BEACON LITE ROAD STOCKPILE CONSTRUCTION DRAWINGS AMENDMENT

EDARP FILE NO.: CDR261

V5_Grading & Erosion Control (GEC) Plan_comments.pdf Markup Summary

BEACON LITE ROAD STOCKPILE
STORM SEWER
PLAN & PROFILES

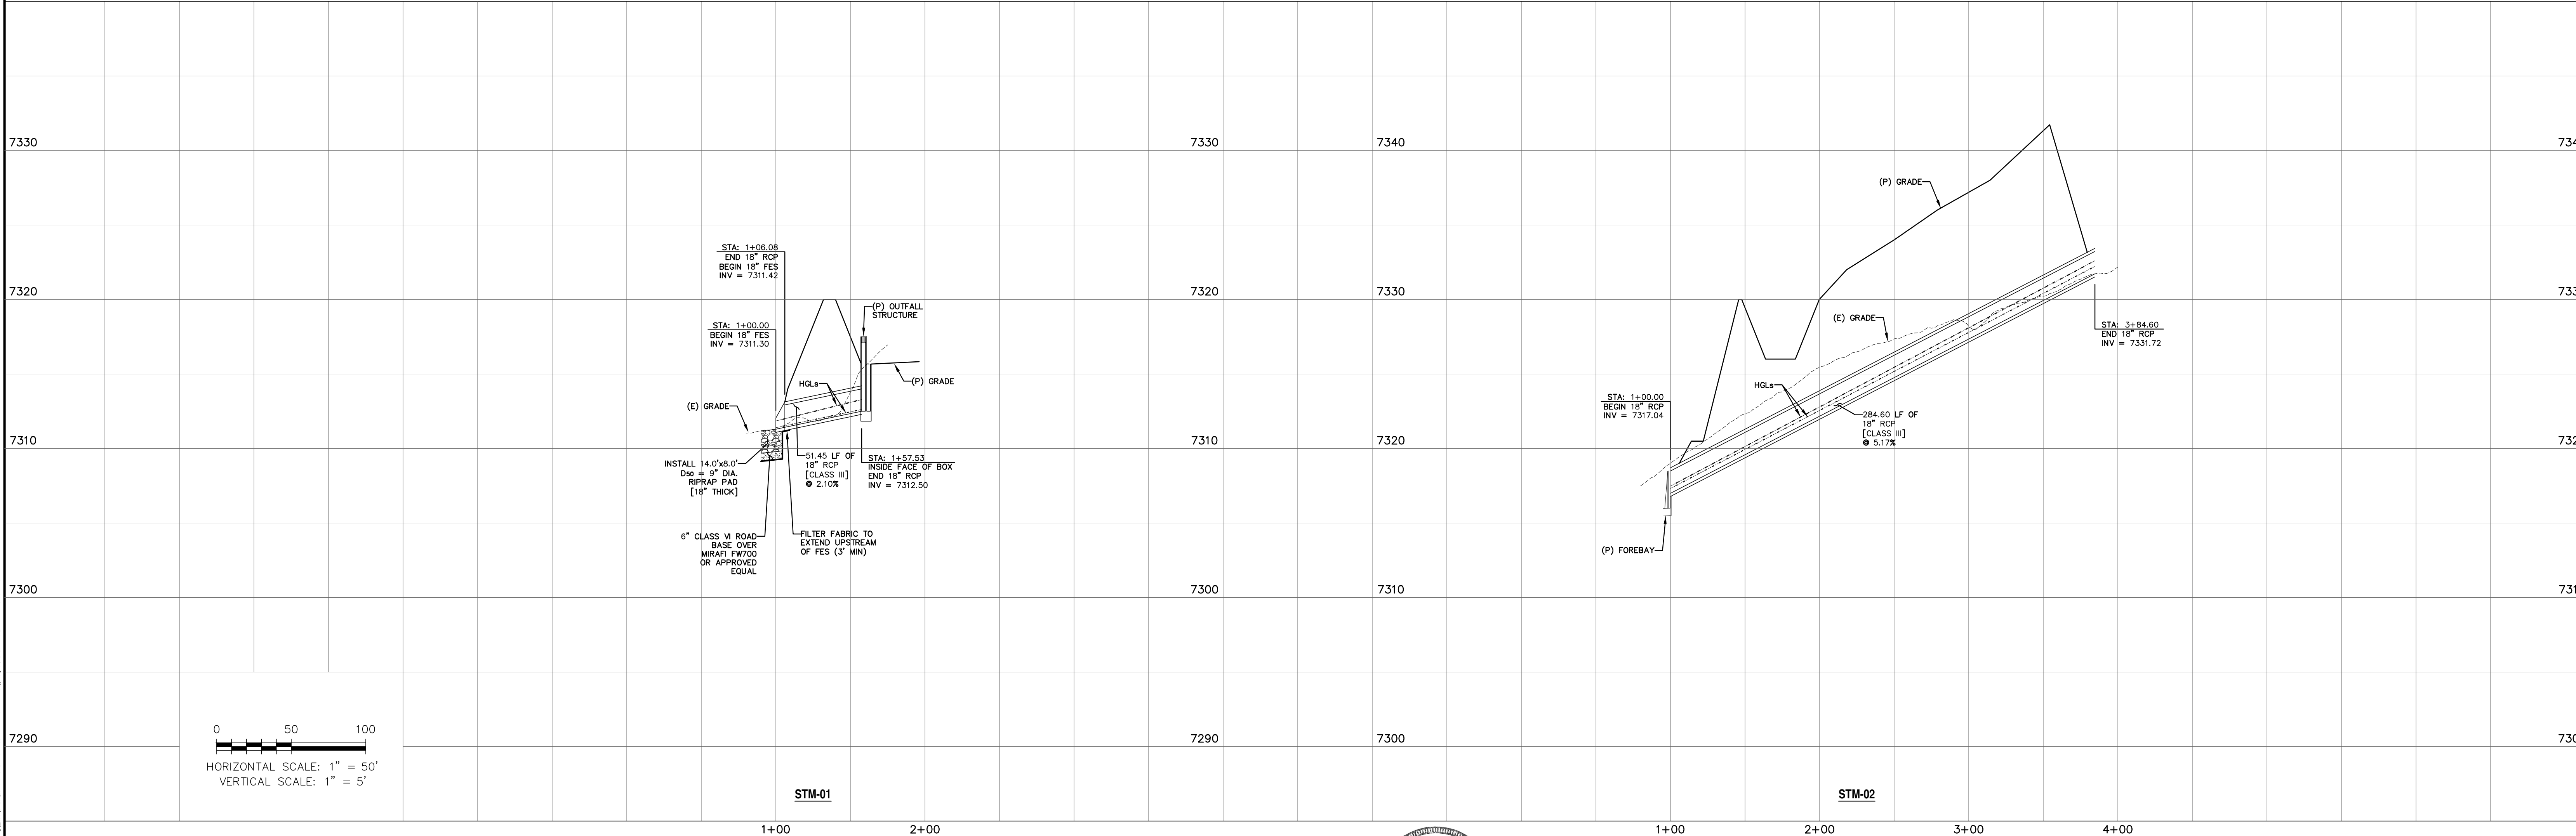
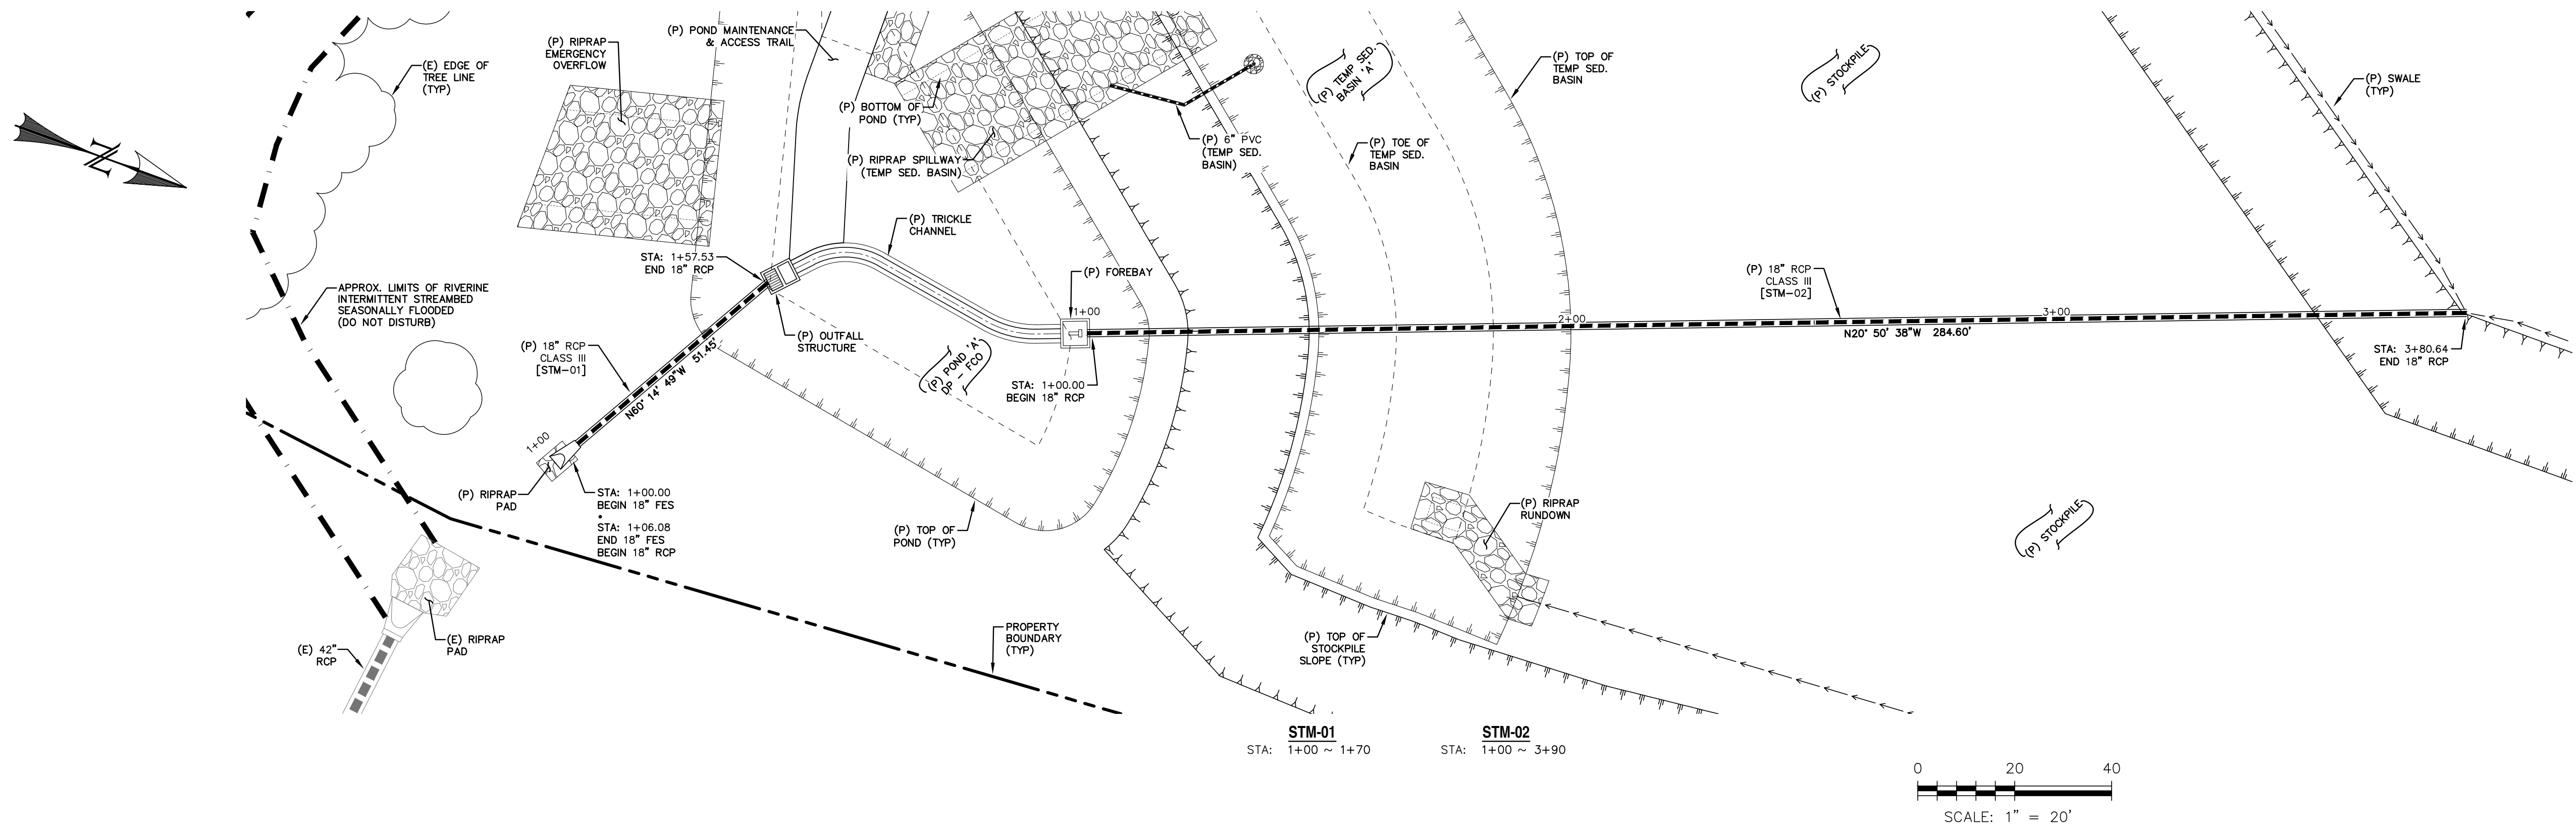
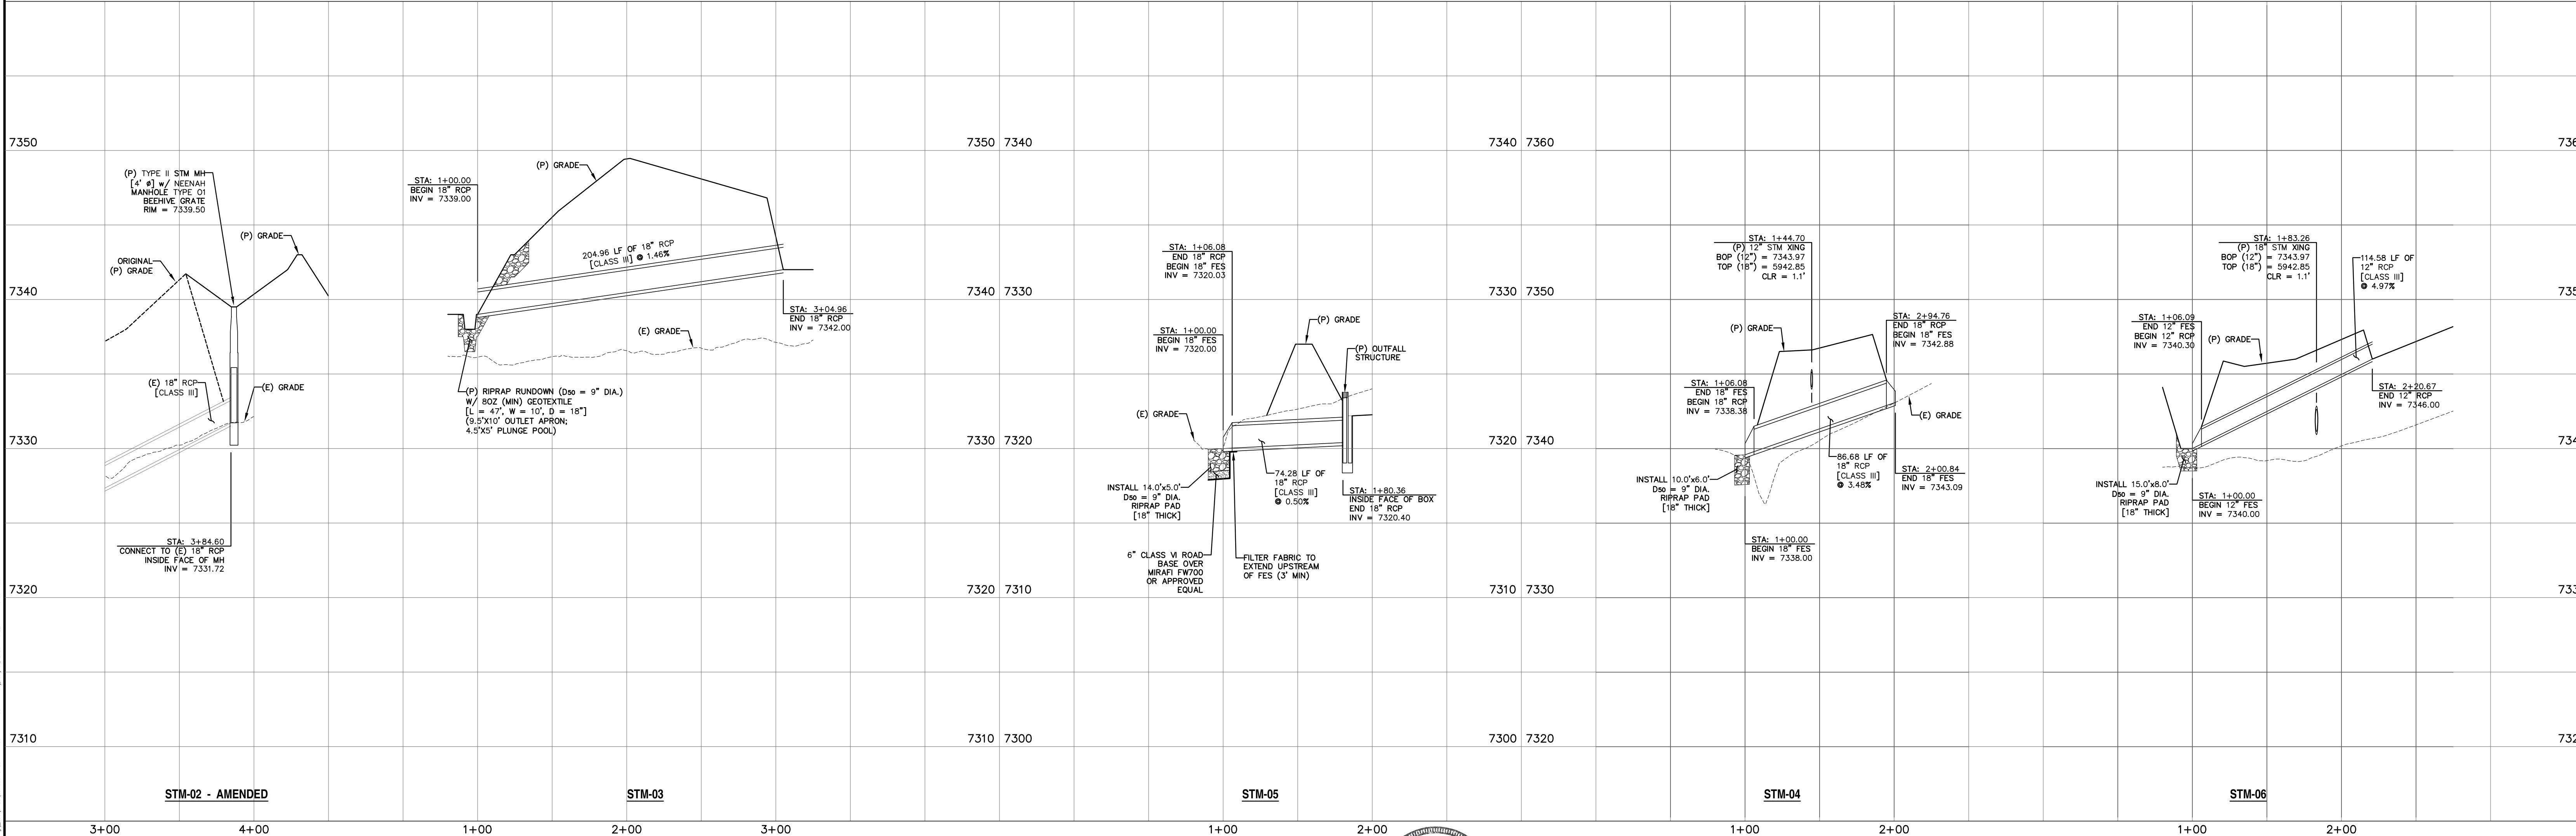
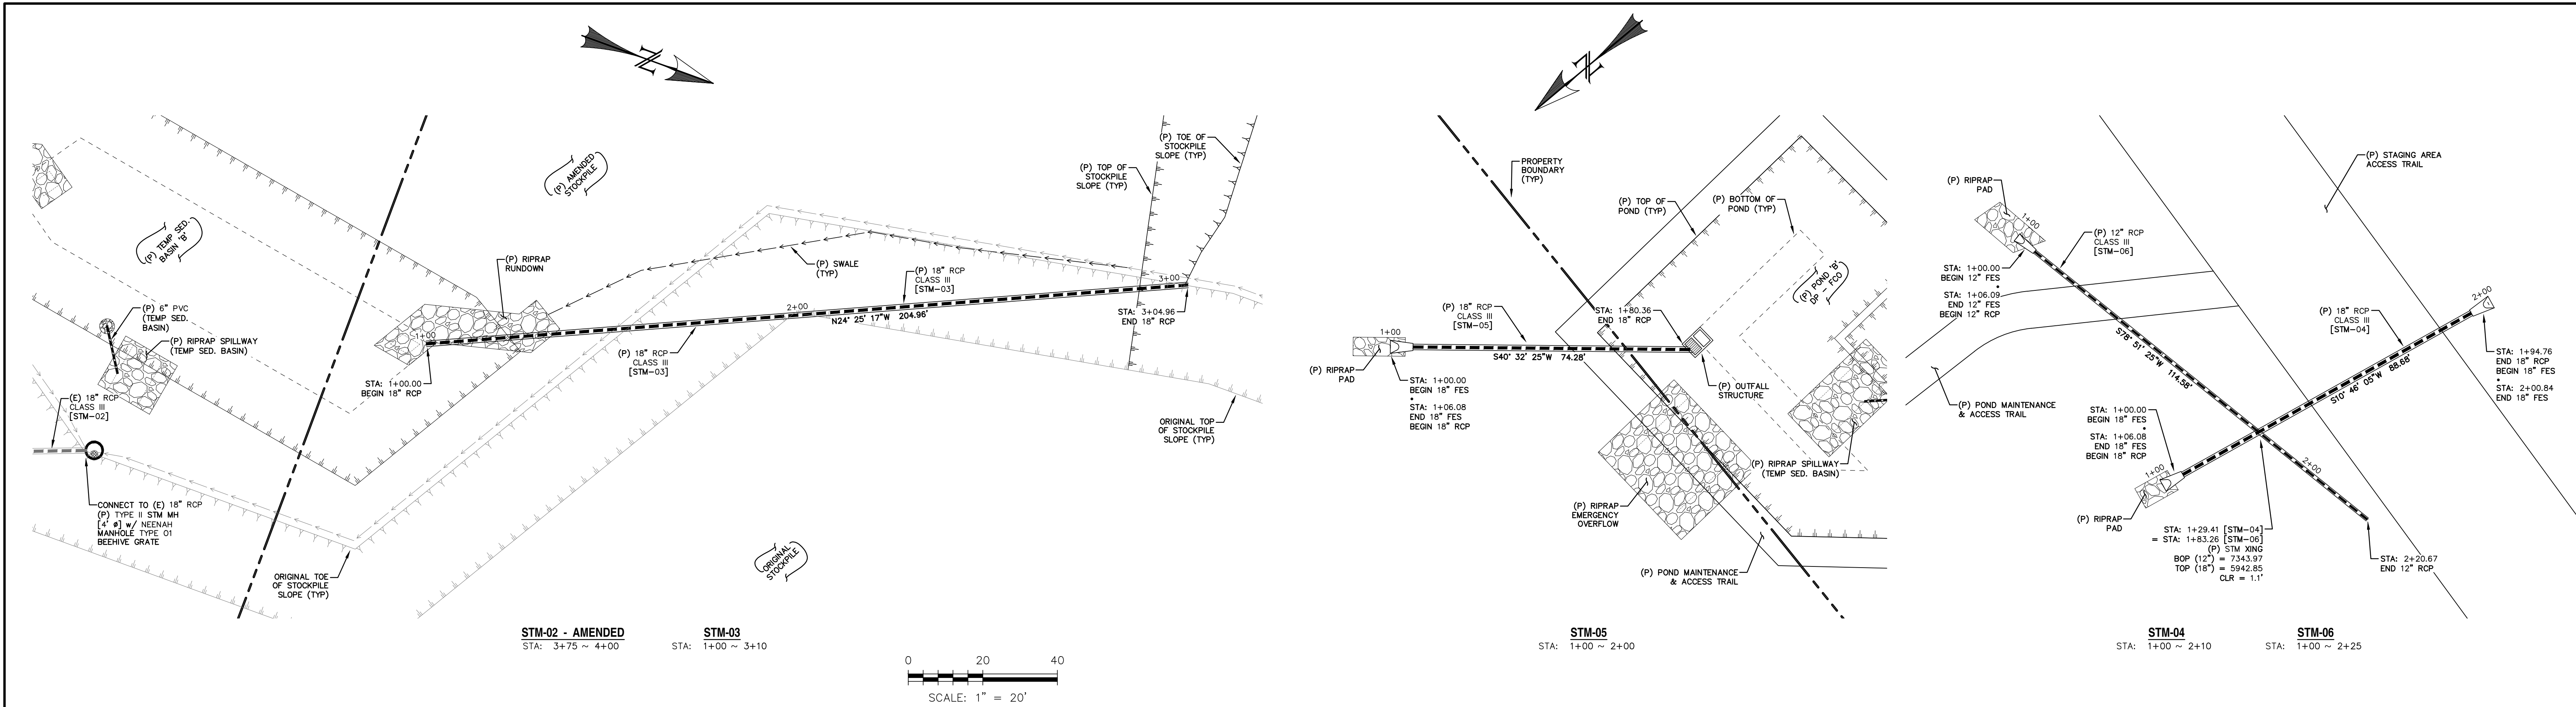
verify whether RCP and riprap need to be extended due to the new grading.

comments have been provided on the drainage report regarding conveyance and erosion at these concentrated outfalls. Revise as necessary
